Product change notification

We are sending this letter to inform you about the changes of the product or products you have purchased. 8devices announces the product change for the Yellow Beet 1.1 modules. More details can be found in the table below:

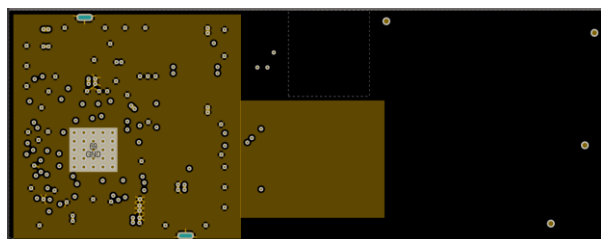
The pictures below reflect the modifications being made in one of the inner ground layers to all 3 versions of YELLOW-BEET modules in order to enhance mechanical stability against bow and twist.
